## Memorandum

**Date:** May 4, 2021  
**To:** Nick Pappani, Raney Planning & Management, Inc.  
**From:** Robert Del Rio, T.E., Luis Descanzo  
**Subject:** Trip Generation and Operations Analysis for the Proposed Manzanita Residential Development in Morgan Hill, California

**Figure 2**  
Site Plan and Project Trips at Driveways

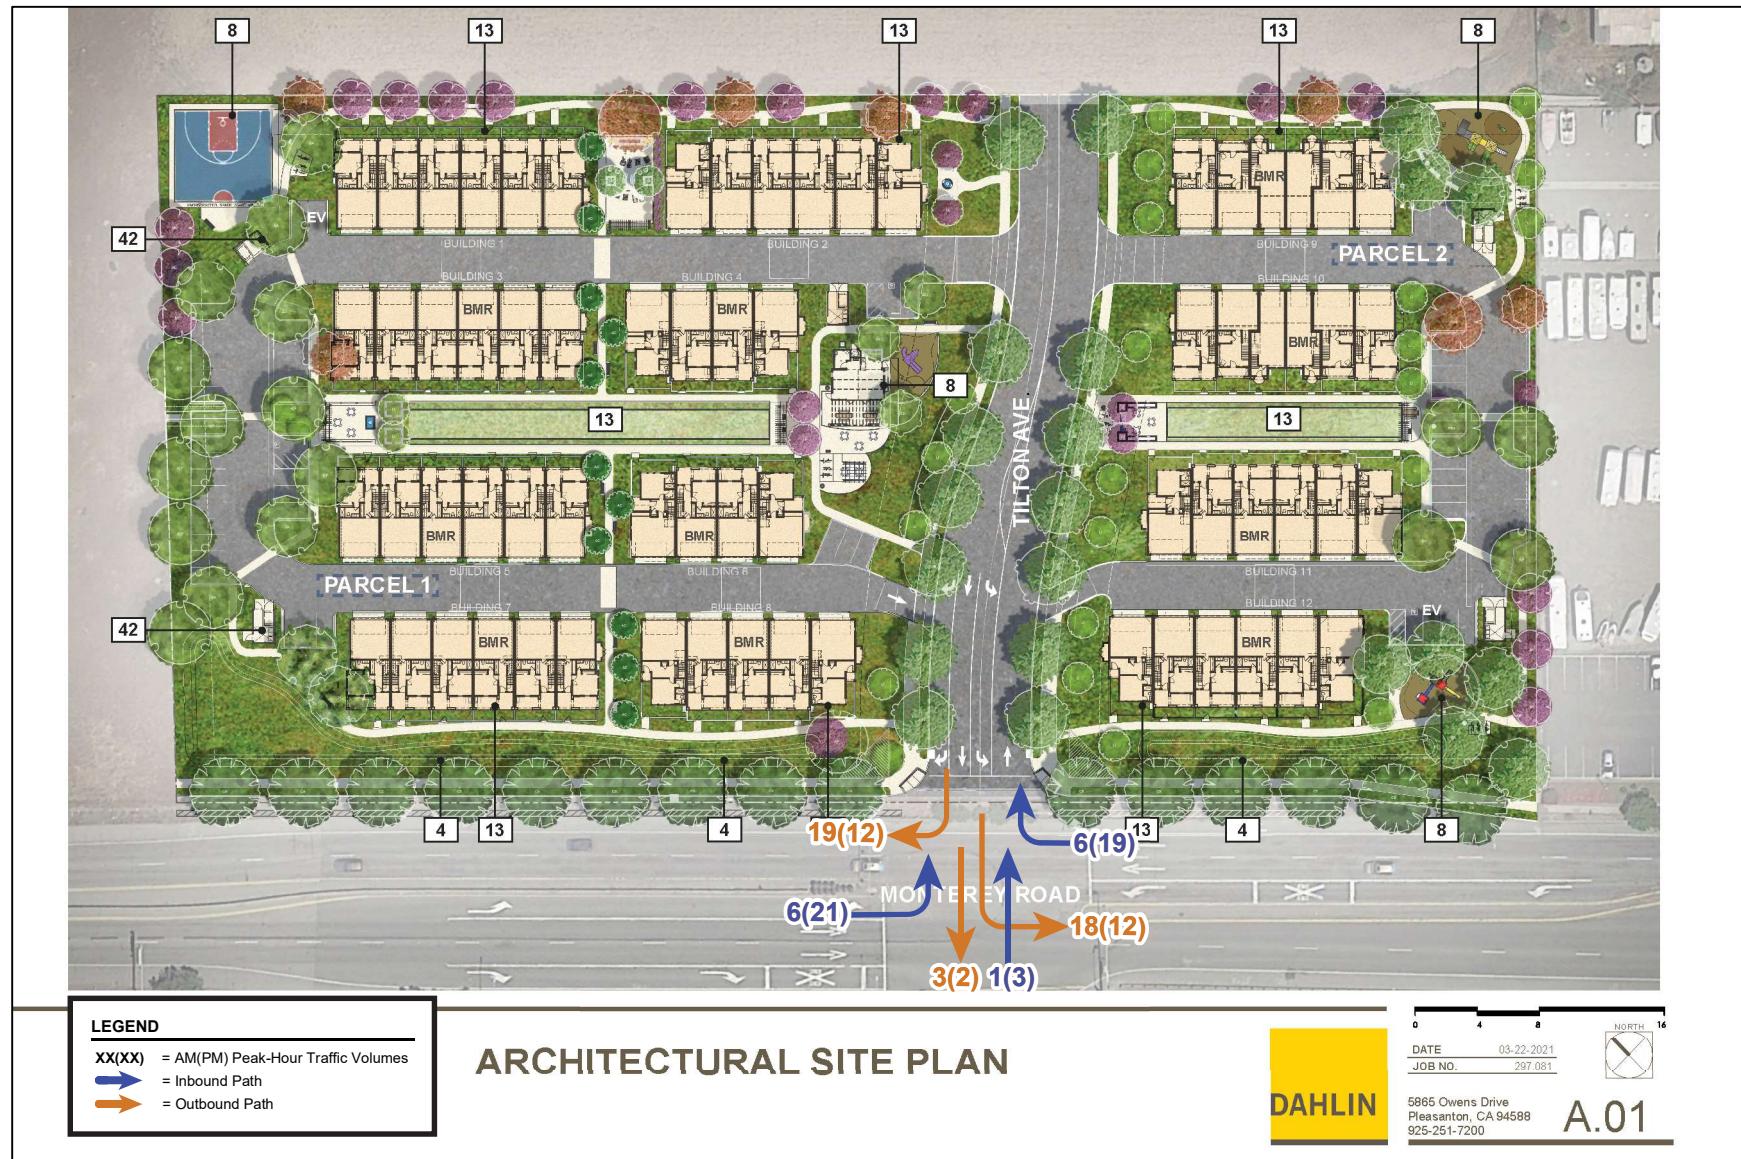
The City of Morgan Hill Design Standards specify a minimum driveway width of 16 feet and a maximum width of 24 feet. The site plan indicates that both full-access driveways along Tilton Avenue are proposed to be 25 feet wide. The City will determine whether it is necessary to narrow the driveways by 1 foot to meet the maximum driveway width standards. The ingress- and egress-only driveways, shown to be approximately 16 feet wide on the site plan, would meet City standards.

The ingress and egress driveways (shown as being angled and channelized on the site plan) would operate as right-in and right-out only driveways and would not conflict with other vehicular movements. However, the driveways would be located in close proximity to Monterey Road, approximately 75 feet. Exiting vehicles from the north parcel driveway would need to cross two travel lanes to access the westbound left-turn lane and may block the lanes on Tilton Avenue at the intersection if more than two vehicles are queued at the intersection.

**Recommendation:** It is recommended that the right-in and right-out only driveways be eliminated. Consolidating all project traffic to the full access four-legged intersection would not create operational issues along the Tilton Avenue extension and would eliminate potential lane blockage on Tilton Avenue at Monterey Road. The driveways can be gated for emergency vehicle access use only if required.

**Figure 4**  
Comparison of Project Trip Distribution and Assignment

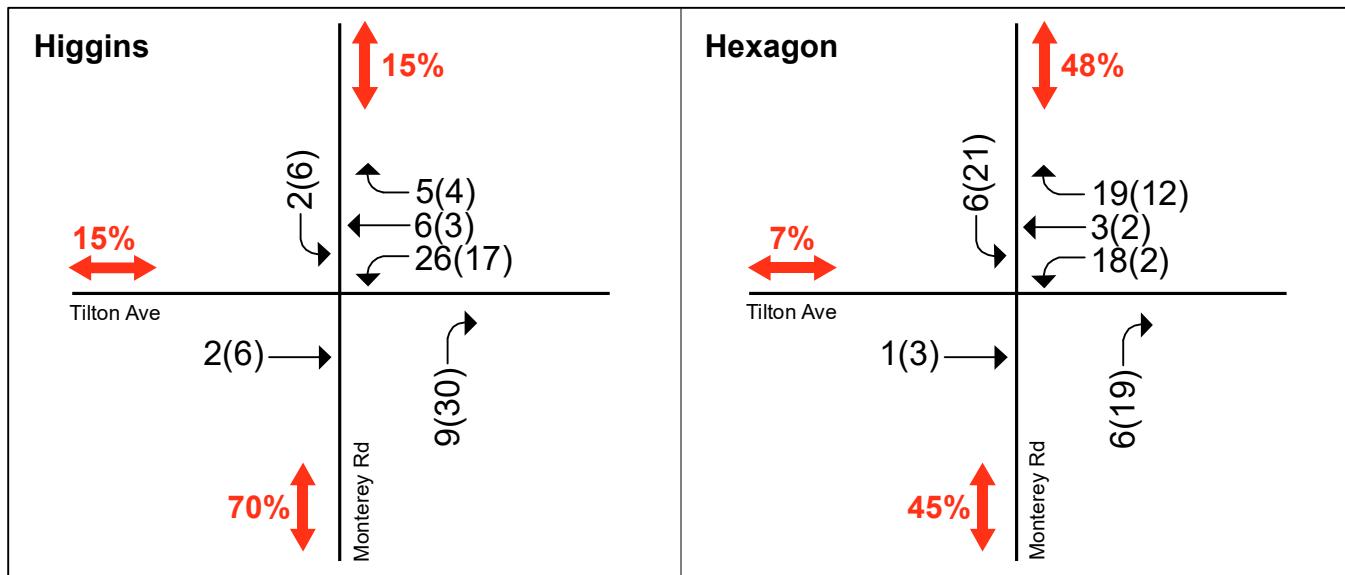
A comparison of the trip distribution and trip assignment used in the Higgins analysis and in this analysis is shown in Figure 4. The Higgins analysis assumes a trip distribution consisting of the following:

The Higgins analysis does not provide a distribution beyond the intersection of Monterey Road/Tilton Avenue. However, with a majority of project traffic assigned to/from south of the project site, it is assumed that the Higgins trip assignment presumed the Cochrane Road freeway entrance/exit would be used by a majority of peak-hour traffic bound to/from US-101.

This analysis assumes that freeway traffic would primarily utilize the Bailey Avenue freeway entrance/exit, which results in a shorter route by approximately two miles compared to use of Cochrane

Road. Overall, the resulting distribution used in this analysis assumes a more balanced usage of Monterey Road to the north and to the south (48% and 45%, respectively) compared to the Higgins distribution (15% and 70% to the north and south, respectively). Usage of Tilton Avenue to access Hale Avenue is approximately double in the Higgins analysis (15%) compared to the percentage assumed in this analysis (7%).
